October 3, 2011

**Re: Proposed Overbank Removal Boundaries and Sample Results
Operable Unit 3, Reach L
Hayton Area Remediation Project**

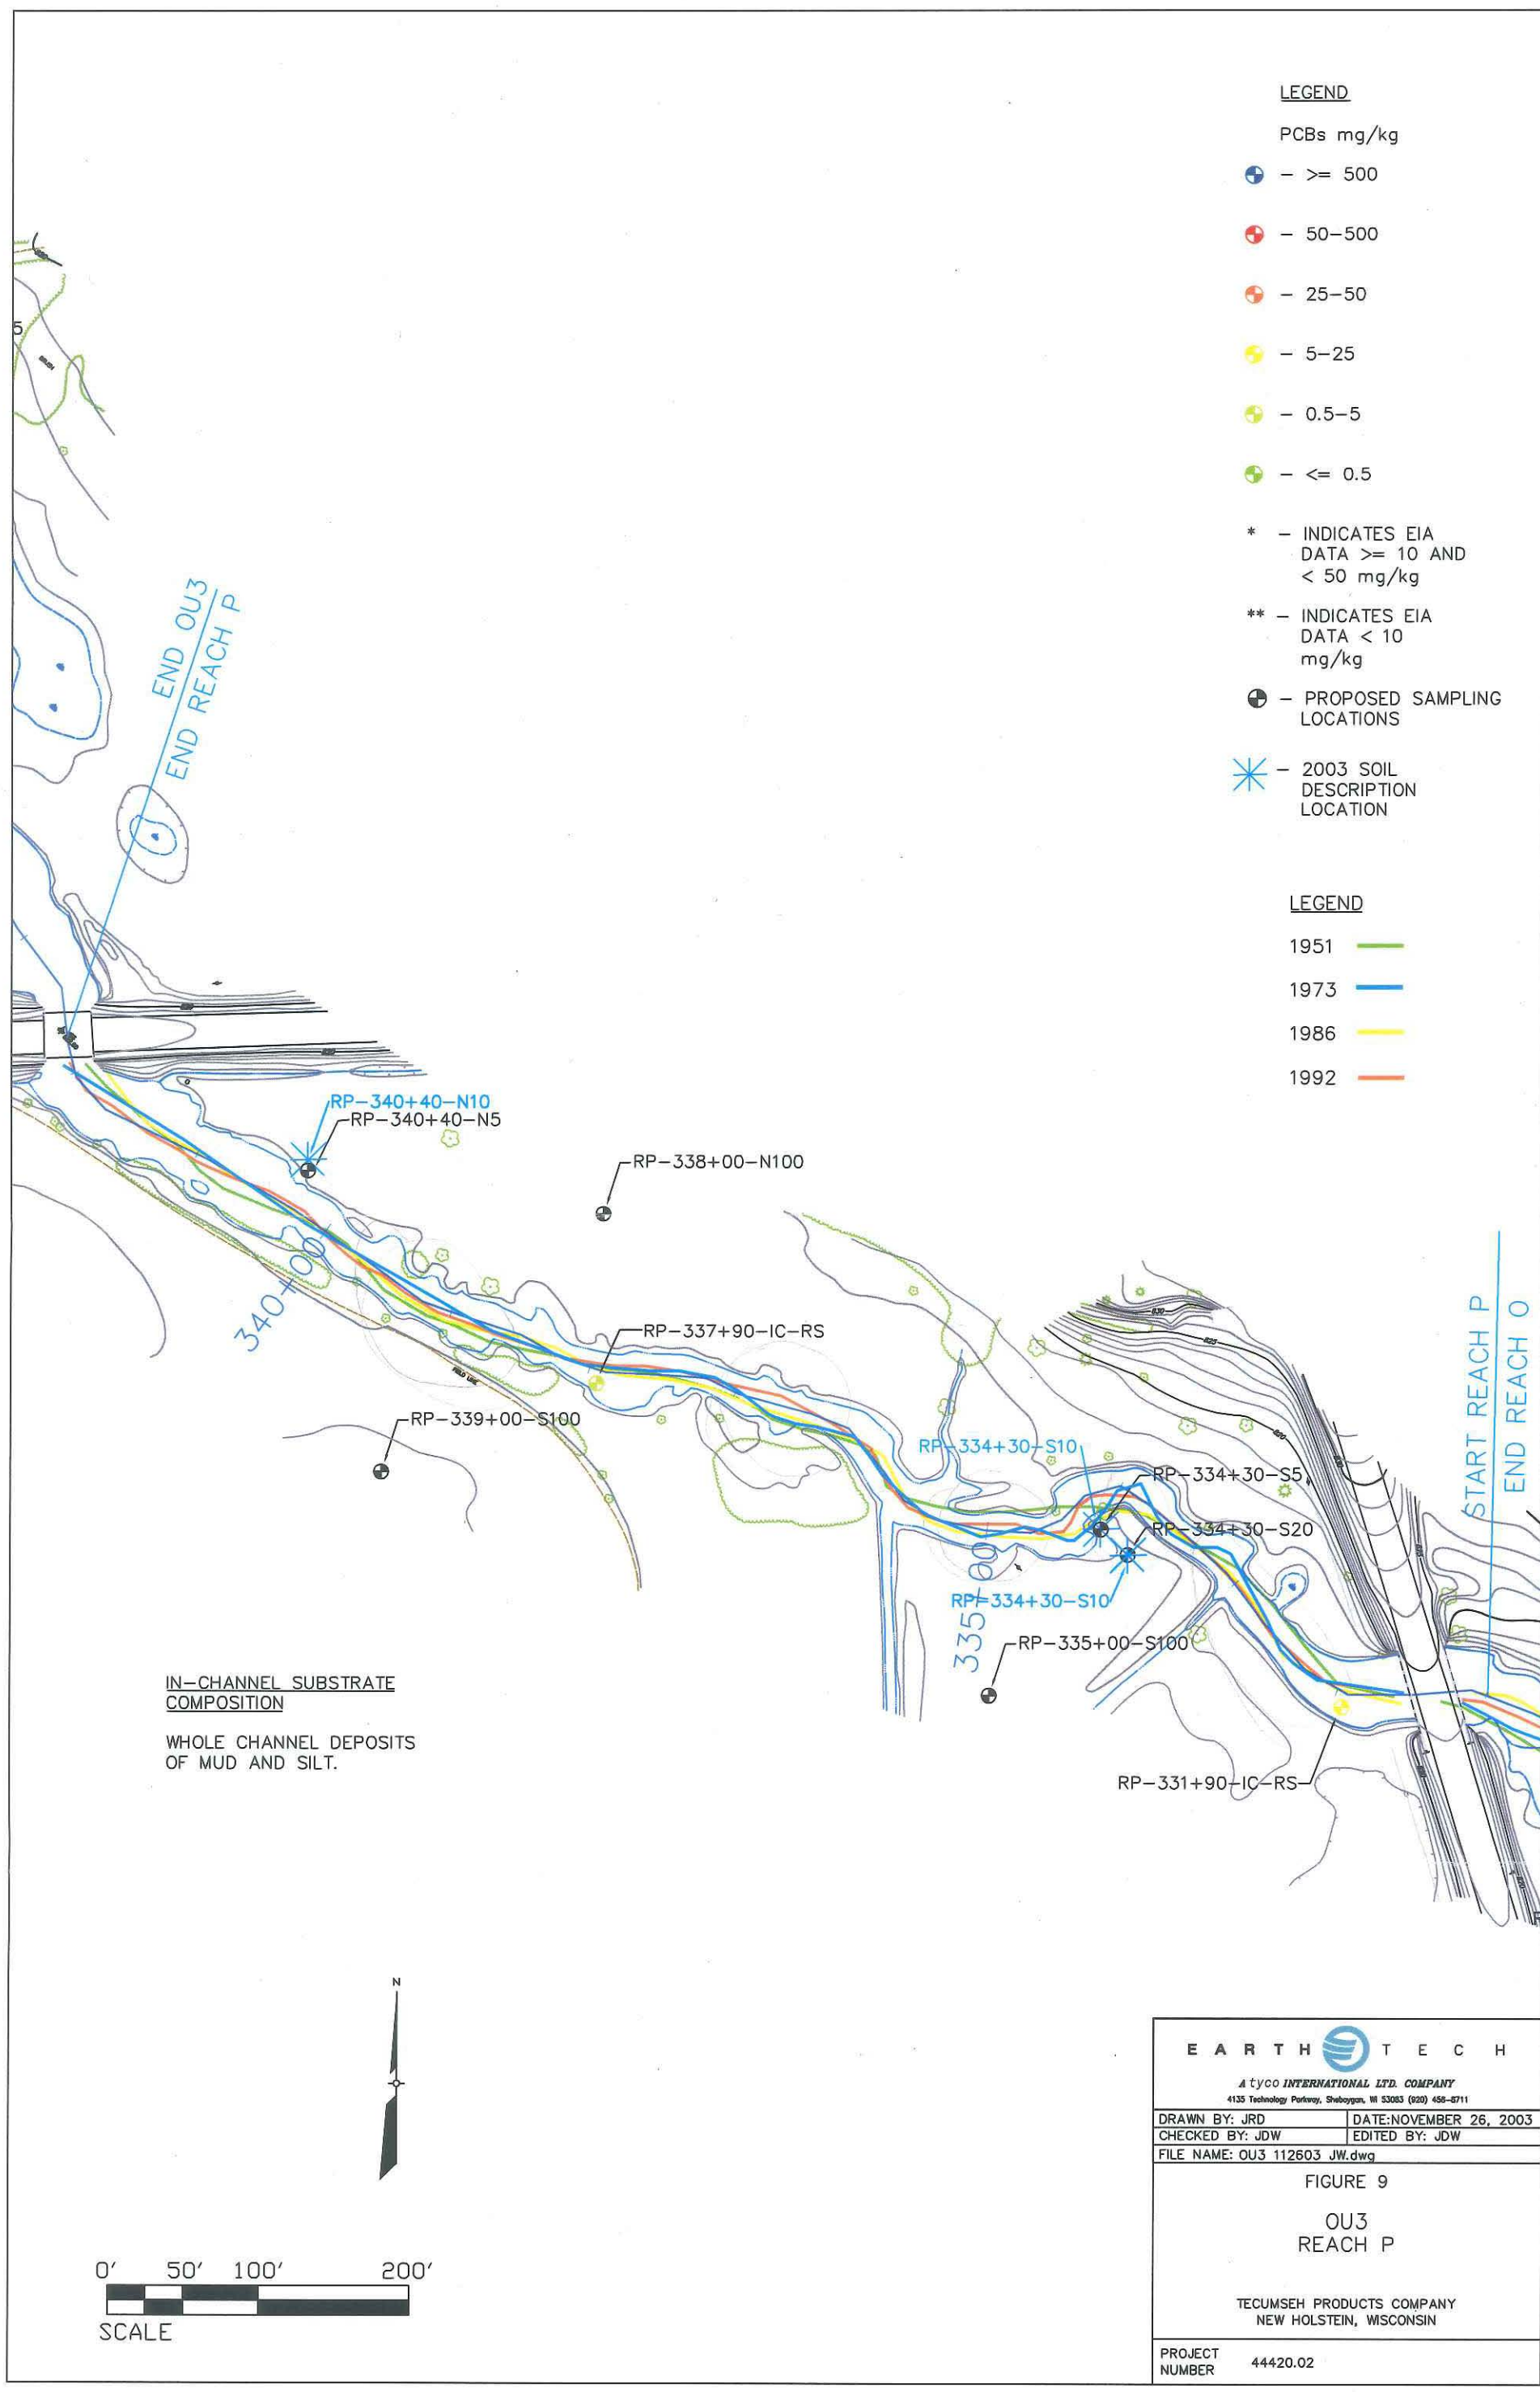
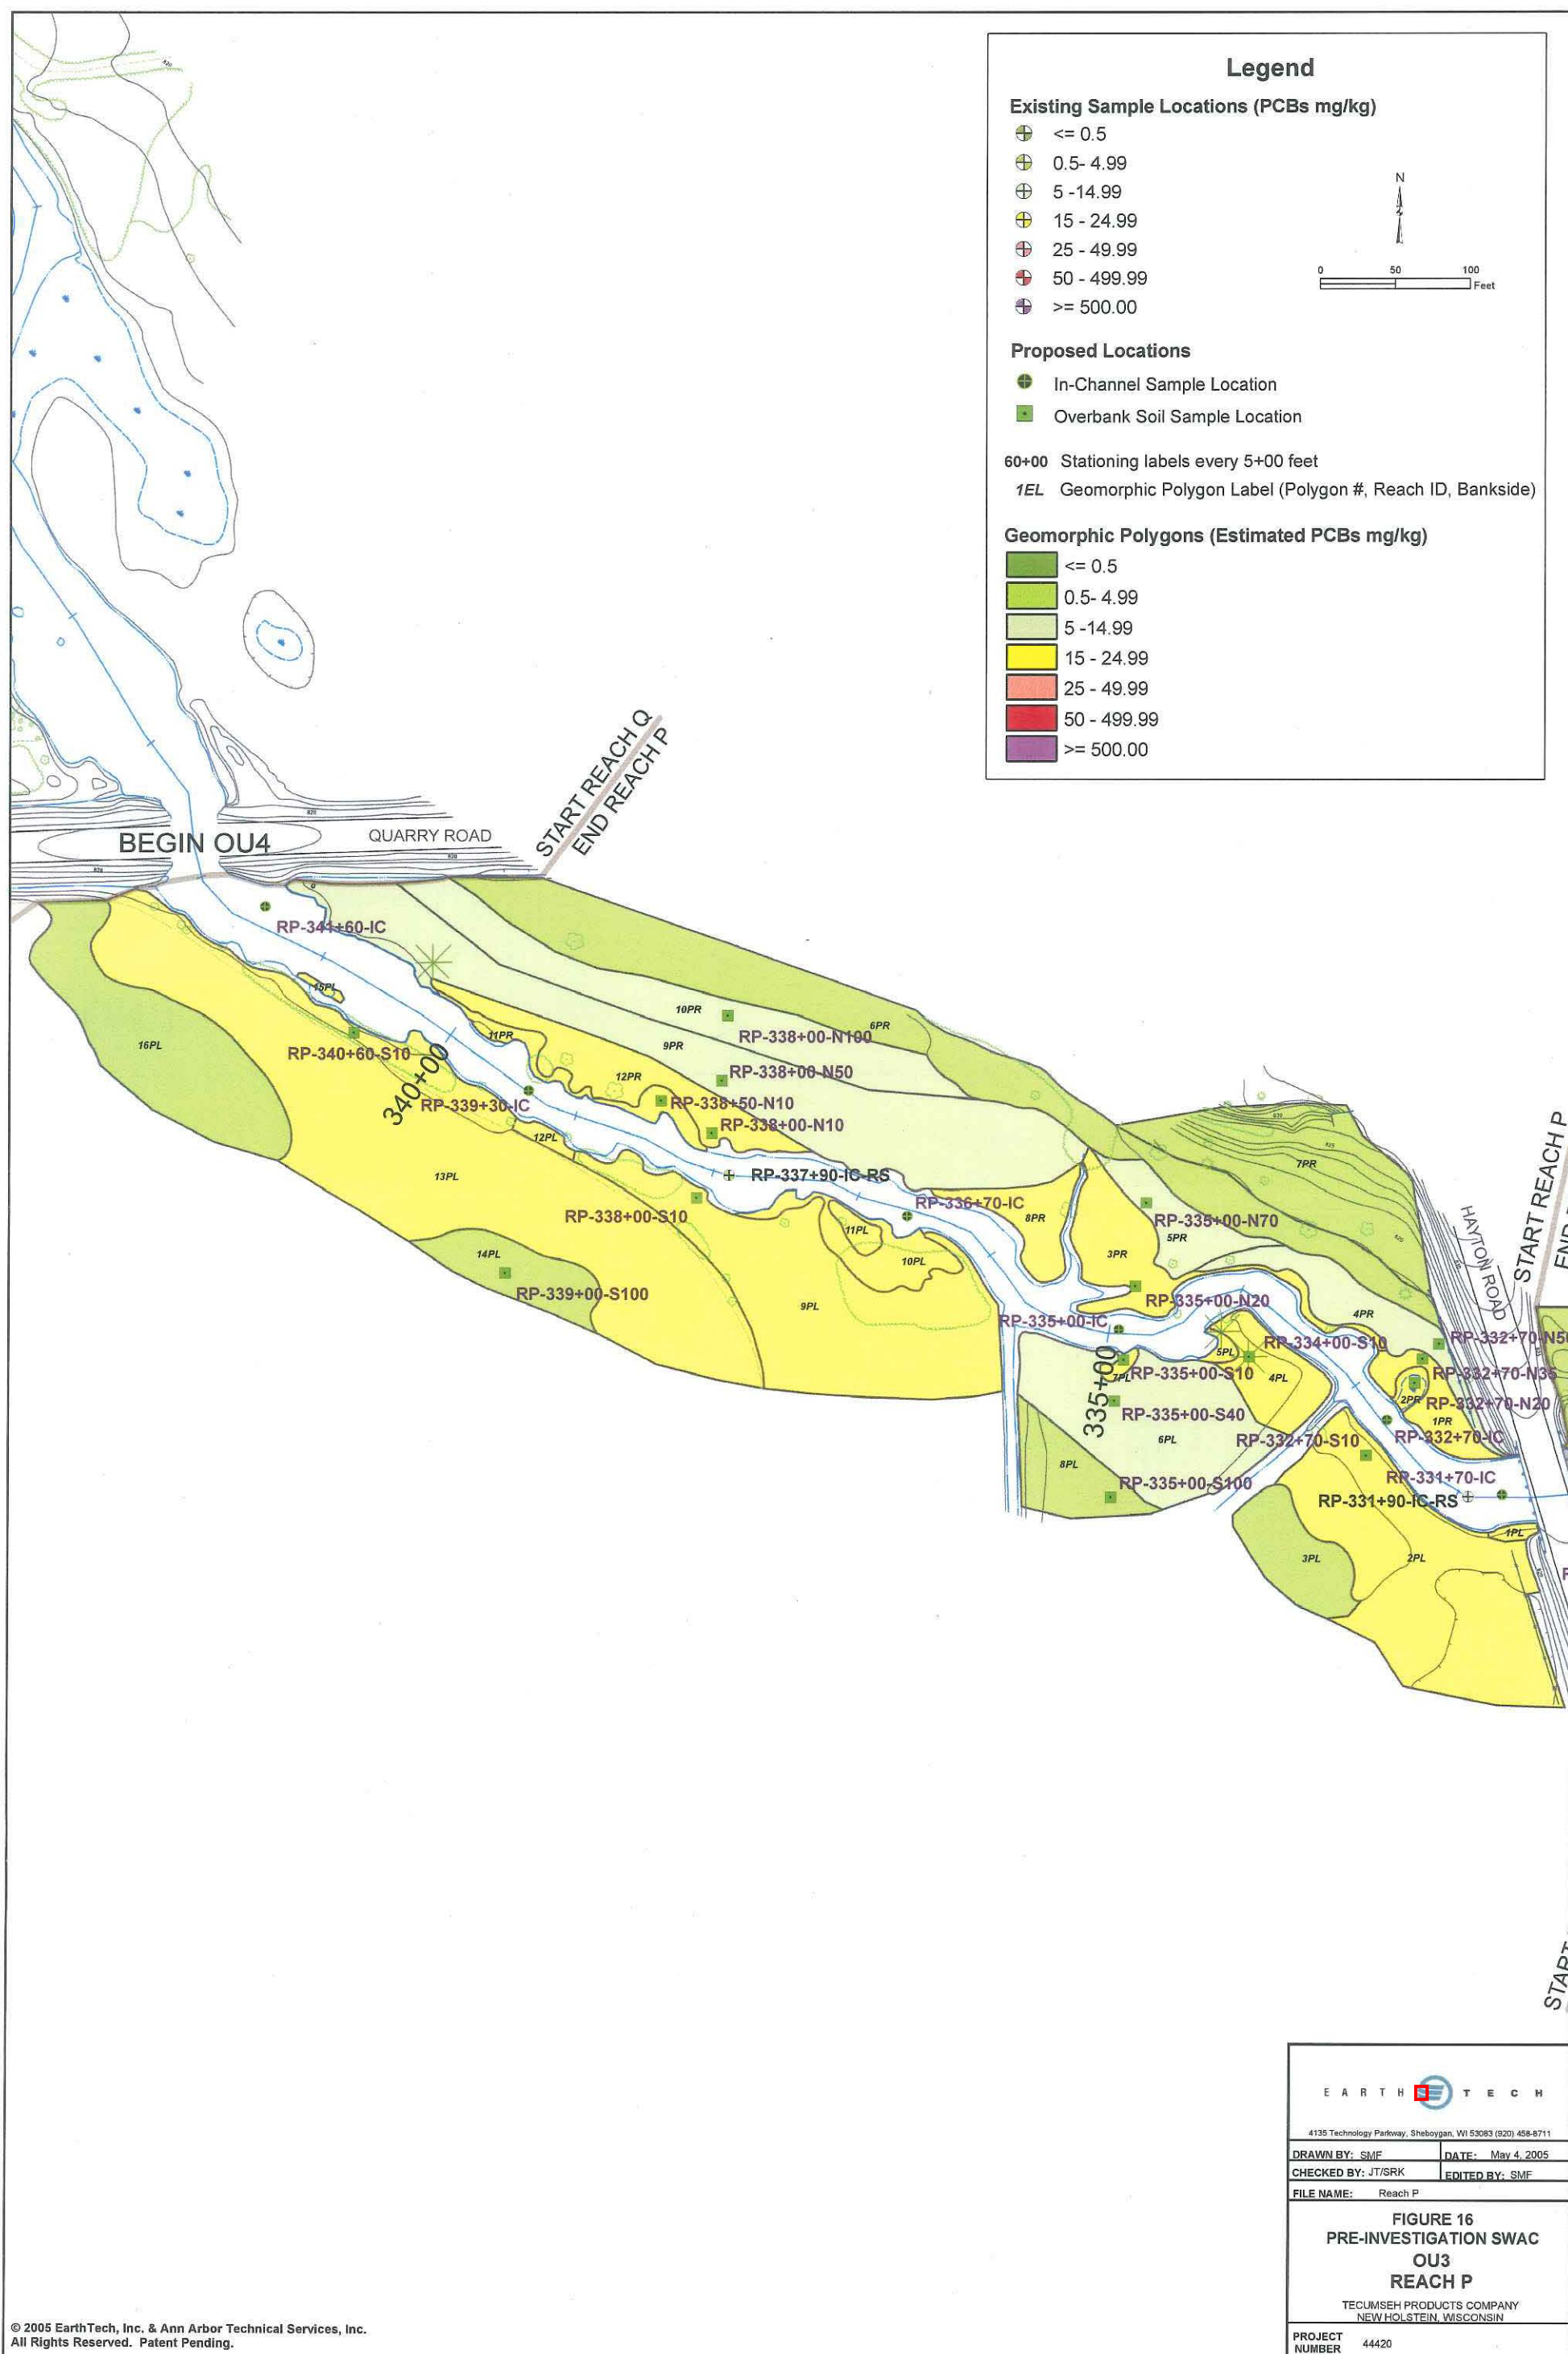
| Polygon | Similar Polygon Identified in Original Sampling Plan and Results from Sampling Similar Polygon |
|---------------|---|
| 8PR | 3PR 12/0.083; sampled 11.3; southern part identified for removal |
| 4PR | There are samples taken at the boundary between 4PR and 1PR and 6PR. Since these are boundary samples, I identified this as having no sampling. |

Comment [jmg1]: I have it identified as no samples in 10PR based on its location in 6PR.
